Responses to Review 2

The authors would like to thank the reviewer for his valuable comments which helped in improving the quality of the manuscript. Our point-by-point responses to the reviewer's comments appear in bold below.

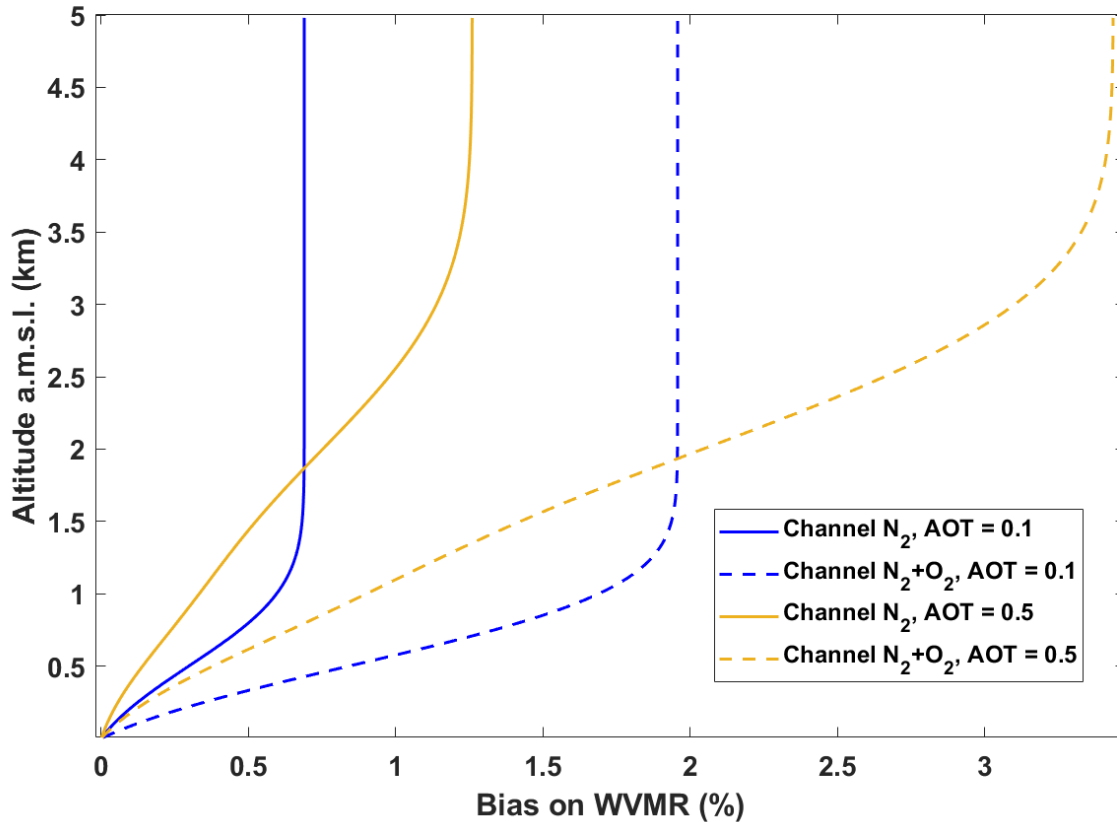
1. From the text, I was left wondering if the various lidar systems are calculating the particle component of the differential transmission calculation. It is not quite clear from the text even though it is addressed at some level. Is it true that the analysis of data from all systems has neglected to calculate the particle component of differential transmission? Please address this explicitly. Even though the AOT may not have been large (something that needs more clarification as noted later), if this calculation is not included in the data reduction it results in a bias in the derived products, not a random uncertainty that could be reduced by averaging. The point is made in the manuscript that neglect of the particle component of differential transmission results in a bias but it seems to be small compared with the magnitude of differences that are found in the analysis. But when lidars are being used as a reference, should any component of the data reduction be neglected? I would argue that it is long past time that the full differential transmission, including both molecules and particles, is routinely accounted for in the analysis of Raman water vapor lidar data and reviewer comments such as this become a thing of the past. Please see the recent paper by DiazZurita et al. (Remote Sensing, 2025), for an example of a way to automate the calculation of the particle contribution to the differential transmission.

1. To address this, please be explicit if the differential transmission due to particles has been included in the data reduction and, if not, state the estimated magnitude of the bias that can result. Better yet, of course, would be for the groups to include this in their analysis but I realize the difficulty of getting that done in a timely manner with 8 different lidar groups since some sort of approximation is likely needed such as done in Diaz-Zurita et al mentioned above. So a clear statement of the estimated bias, lidar by lidar, would suffice although I sincerely hope the community makes progress toward routinely including this in their analysis of Raman water vapor lidar data.

Indeed, for all lidars, the differential transmission correction related to aerosols was not taken into account. The reviewer is correct in noting that a discussion justifying this choice was

missing. We have therefore added this discussion in Appendix B in order to preserve the original structure of the manuscript.

“B2.1 Bias linked to the differential aerosol transmission

This bias is due to the difference in wavelength between the H₂O Raman channel (~407 nm) and the channel used as a reference, which is either a rovibrational channel on dinitrogen (N₂) (387 nm) or a rotational channel on dinitrogen and dioxygen (N₂ + O₂) (~355 nm).

During the WaLiNeAs field campaign, we observed two contrasting scenarios regarding aerosol loading in the lower and middle troposphere, as recorded by all the lidars. The first scenario corresponds to a typical boundary layer load, with an AOT of less than or around 0.1 at 355 nm. AERONET data (<https://aeronet.gsfc.nasa.gov>) show variable Ångström exponents of up to ~1.5, averaging around 1. The second scenario is similar to the first, but with the addition of layers of Saharan aerosol plumes, which can lead to AOT of around 0.5 and Ångström exponents of around 0.5 or lower. Based on these two situations, we estimated the bias associated with aerosol-related differential transmission in the lower (≤ 1.5 km a.m.s.l.) and middle (≥ 1.5 km a.m.s.l.) tropospheres. The values are shown in Table B1, and the corresponding vertical profiles of bias are given in Figure B1. In the PBL, the bias remains below 0.7% (2%) for lidars using a rovibrational (rotational) channel. In the presence of dust aerosol layers, biases of less than 0.5% (1%) can be observed in the PBL and 1.3% (4.7%) in the free troposphere. Above 3 km a.m.s.l., aerosol-related bias significantly influences lidars using a pure rotational channel, where WVMRs predominantly remain below 10 g kg⁻¹.

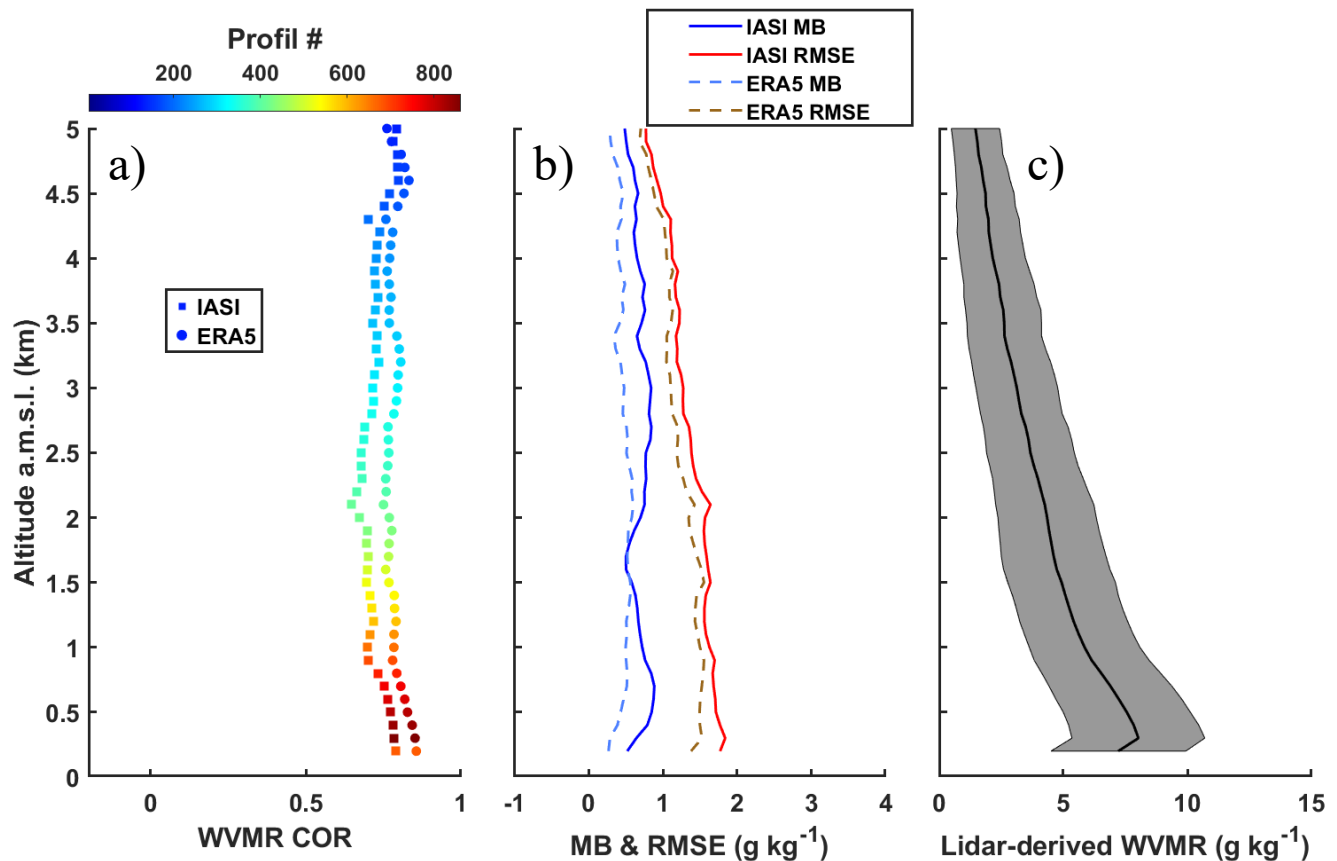
4. It is difficult to assess the magnitude of the effect of the neglected height dependent calculations that are being requested above since nowhere in the paper nor in the supplement are the mean lidar, IASI, ERA5 profiles of water vapor mixing ratio shown. Please add mean mixing ratio profiles to figures 4 and 5 (and to figs S18 – S25 in the supplement), perhaps as a third panel. This will greatly aid understanding the measurements in general.

We have added the mean vertical profiles of the water vapor mixing ratio as a third panel. An example is given below.
